**TEXAS UTILITIES GENERATING COMPANY**  
SKYWAY TOWER • 400 NORTH OLIVE STREET, L.B. 81 • DALLAS, TEXAS 75201

SUBJECT: COMANCHE PEAK STEAM ELECTRIC STATION  
DOCKET NOS. 50-445 AND 50-446  
PROCESS CONTROL PROGRAM

Attached is the CPSES process control program used for the solidification of radioactive wastes. Also attached is the relevant CPSE§ FSAR Section 11.4, revised for Amendment 54.

## 11.4 SOLID WASTE MANAGEMENT SYSTEM

FIGURE 11.4-1

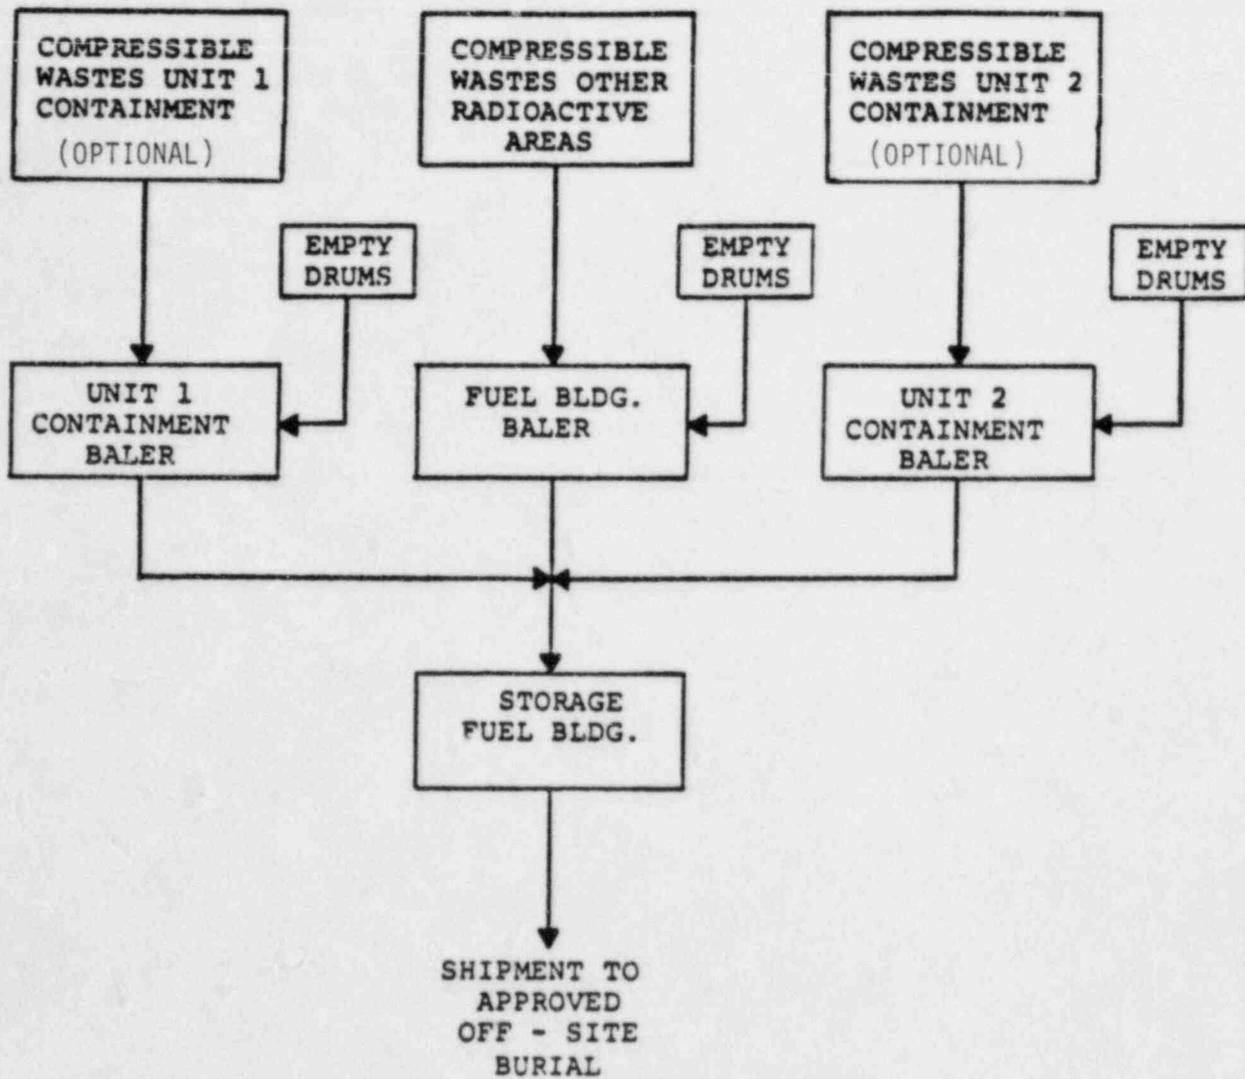
(DELETED)
